ADDENDUM #3

Reference: Restroom Remodel – Dead Horse Point State Park
Division of Parks & Recreation – Moab, Utah
DFCM Project No. 07321510

ADDENDUM NO. 3

Dead Horse Point
Restroom Improvements
Division of Parks and Recreation
State Road 313, P.O. Box 609
Moab, Utah
DFCM Project No. 07321510

FLOOR PLAN

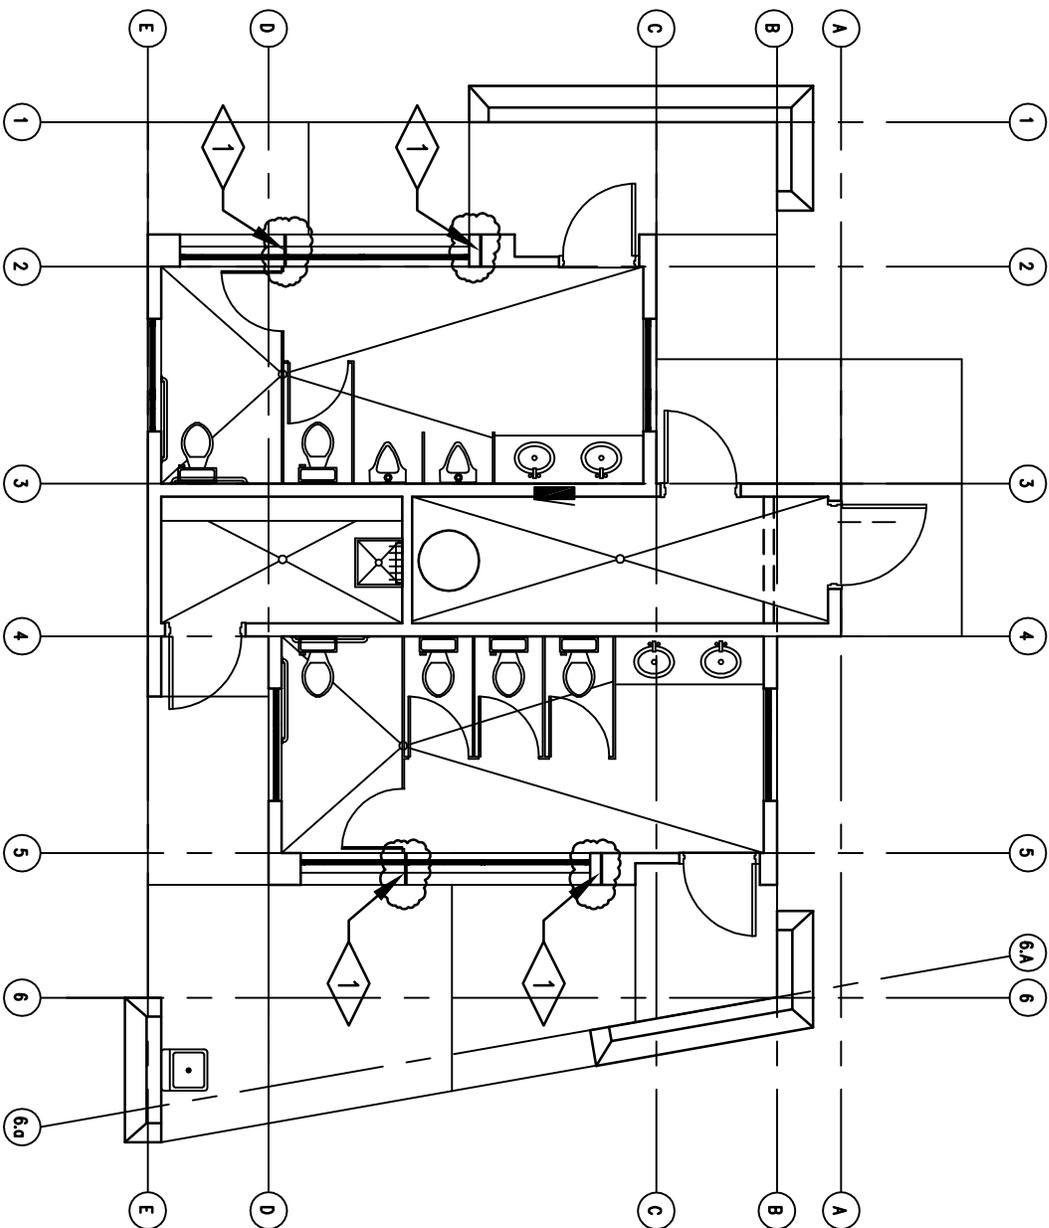
1. See attached addenda drawing A 3.0 indicating locations where general contractor shall provide one layer of 5/8" type "x" gypsum board set vertically inbetween double wood stud wall framing.

1 AT BUBBLED LOCATIONS SHOWN, THE GENERAL CONTRACTOR SHALL PROVIDE ONE LAYER OF 5/8" TYPE "X" GYPSUM BOARD SET VERTICALLY IN BETWEEN DOUBLE WOOD STUD WALL FRAMING AS REQUIRED FOR FIRE BLOCKING AS PER IBC SECTION 717.2.2.
